BULLETIN

NUMBER 91

SUBJECT: Inspection of Fuel Strainer Installation

MODELS AFFECTED: Piper J3C-65 Airplanes
Serial Nos. 14027 through 17959

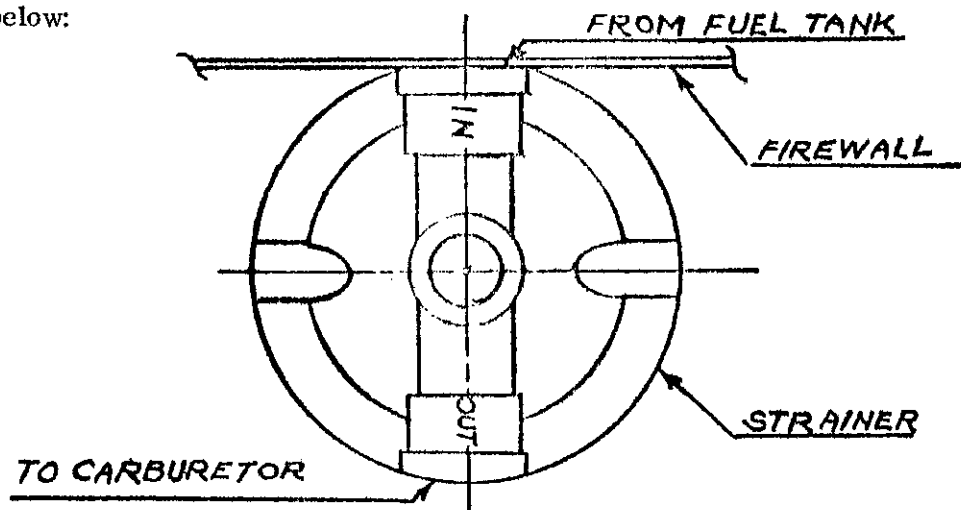
It has been brought to our attention that several J3C-65 airplanes have left the factory with the fuel strainer ports inadvertently reversed. Therefore, we are requesting that all owners inspect their airplanes for proper installation.

The ports are identified by the words "IN" and "OUT" in raised letters on the strainer cover. The proper installation and location of ports is shown below:

If the fuel strainer is not installed as indicated above, it should be reversed for proper fuel flow.

An appropriate entry should be made in the aircraft log book at the time this inspection is made.
